IFB No. **17-22 Lewis Lemon Elementary School Additions & Renovations**

RE: **ADDENDUM NO. 2**

Project No.: RPS# 17-22
Date: JANUARY 25, 2017
Subject: CHANGES TO BIDDING DOCUMENTS
Project: CAFETERIA ADDITION AND REMODELING TO LEWIS LEMON ELEMENTARY SCHOOL
ROCKFORD PUBLIC SCHOOLS
ROCKFORD, ILLINOIS
Bids Due: 2:00PM, WEDNESDAY, FEBRUARY 1, 2017
From: RICHARD L. JOHNSON ASSOCIATES, INC.
4703 CHARLES STREET
ROCKFORD, IL 61108
To: ALL PROJECT DOCUMENT HOLDERS

2 CONCRETE PIERS
Scale: N.T.S.

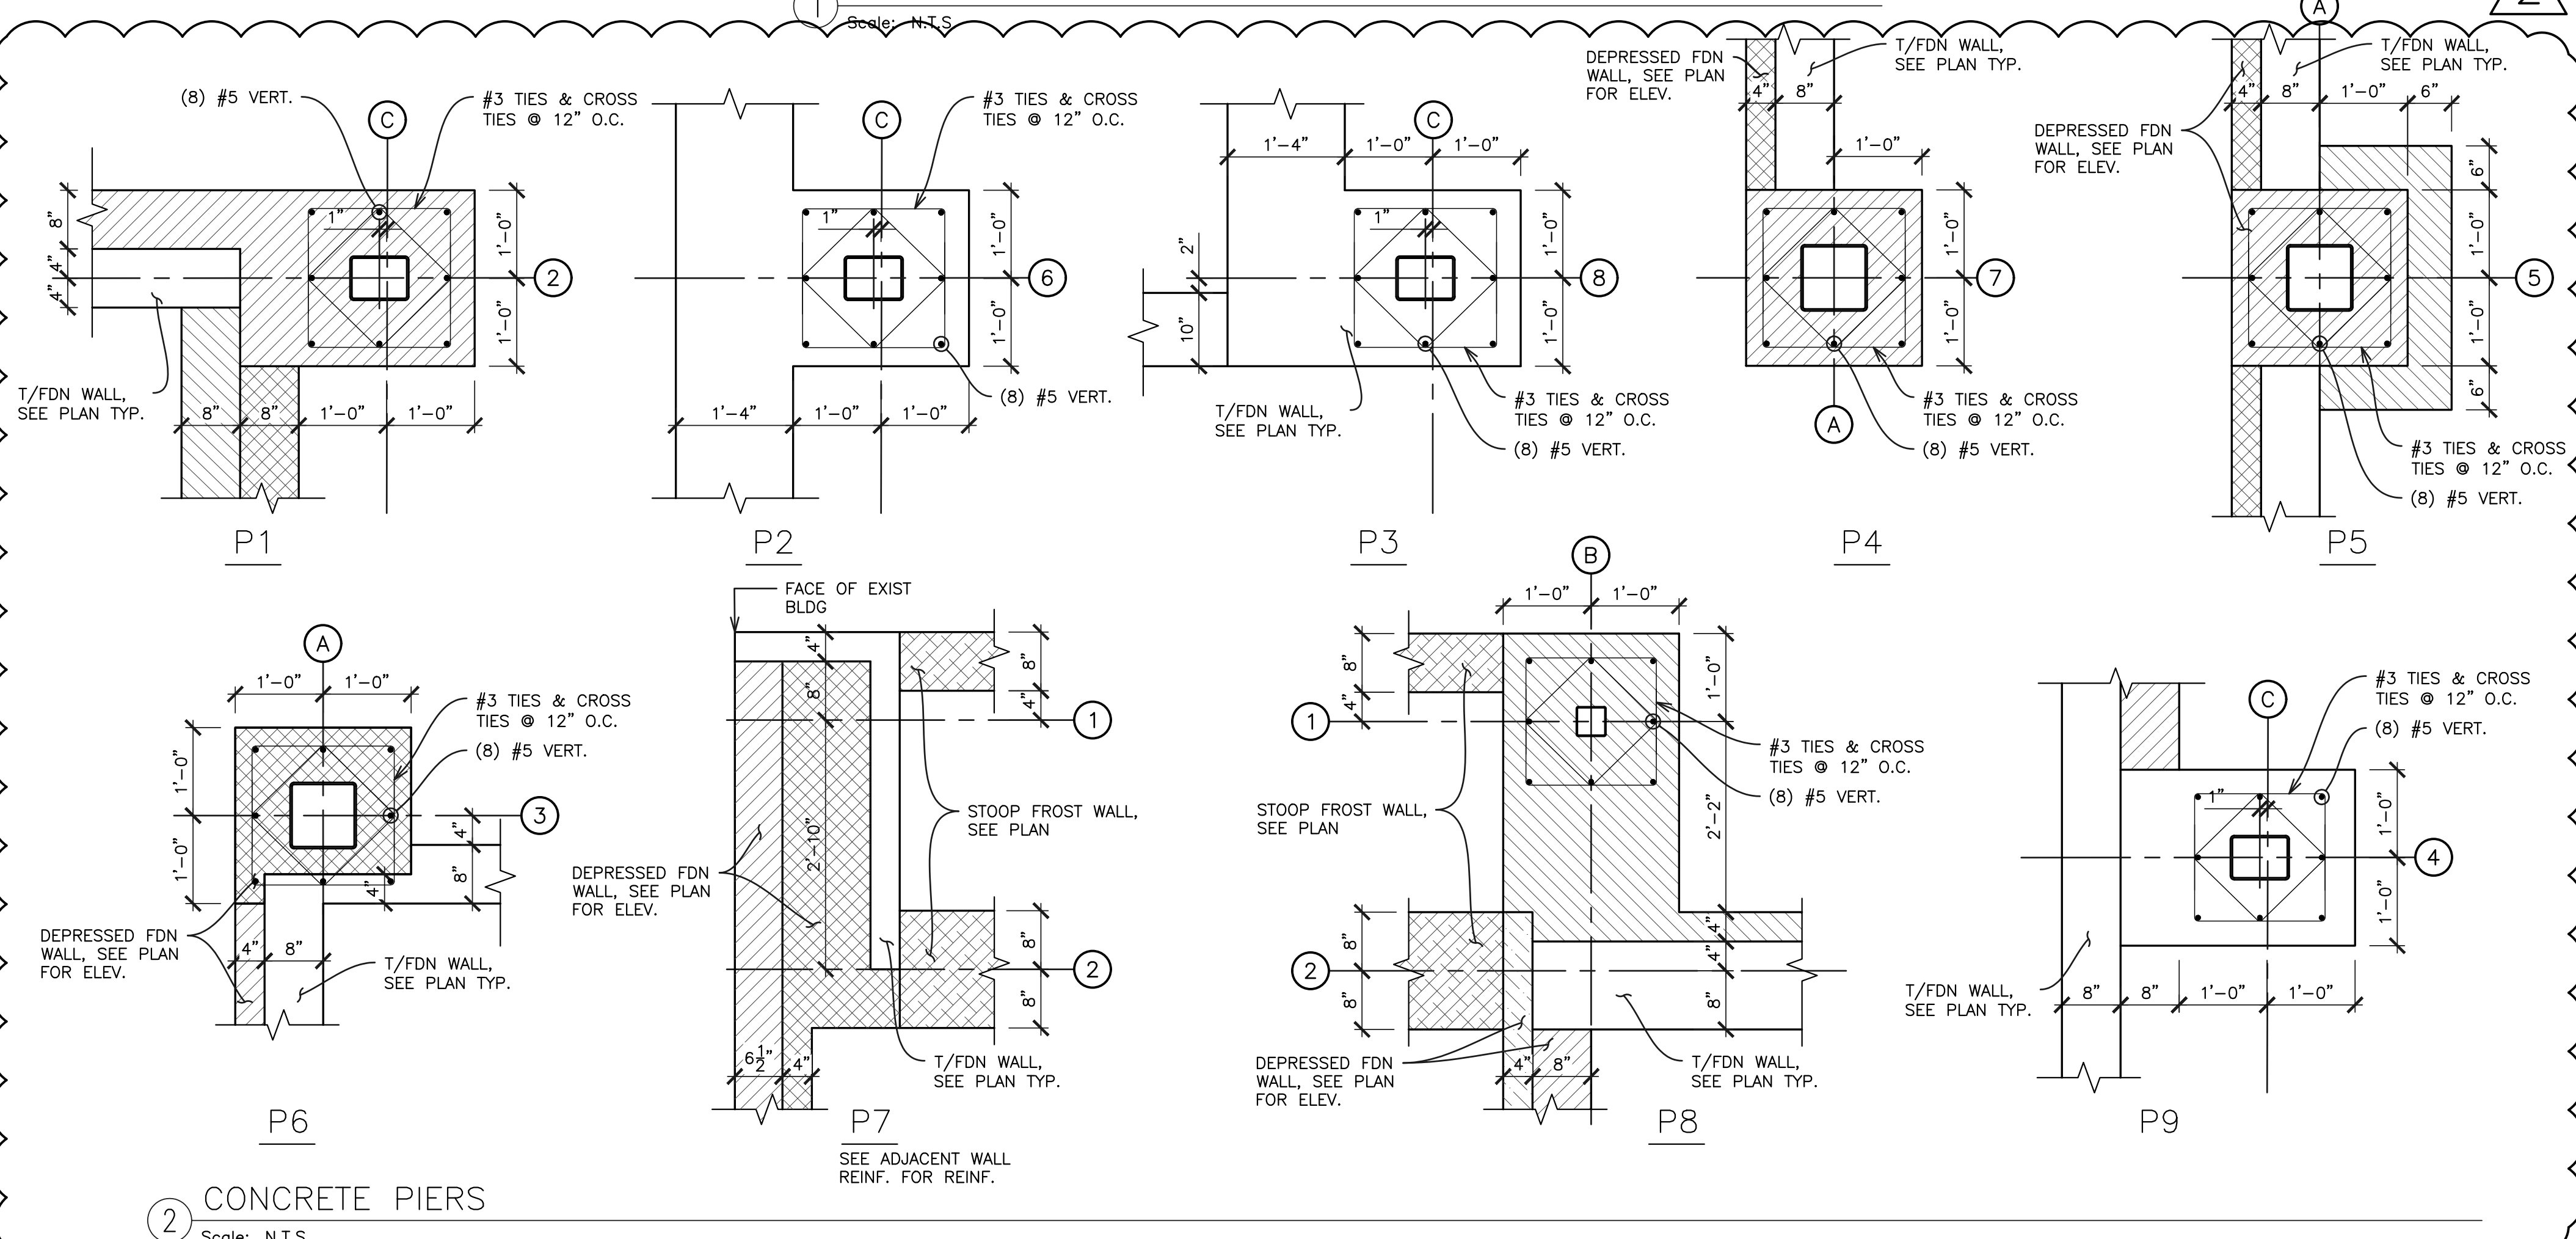
- 7.1. Question #1) Please provide reinforcing detail for footing/pier as shown on Drawing S3 (Footing Detail #6, #9, #11A, #14 & #15), on Drawing S4 (Footing Detail #3, #5, #6 & #8) and on Drawing S6 (Pier Detail #2)

Answer #1) Detail 6/S3, 9/S3, 11A/S3, & 15/S3, reinforcing is shown on drawings.
Detail 14/S3 is an existing foundation.
Detail 2/S6 reinforcing will be clarified by addendum.

5.1. Remove sheet S6 dated October 31, 2016 and replace with sheet S6 dated January 25, 2017
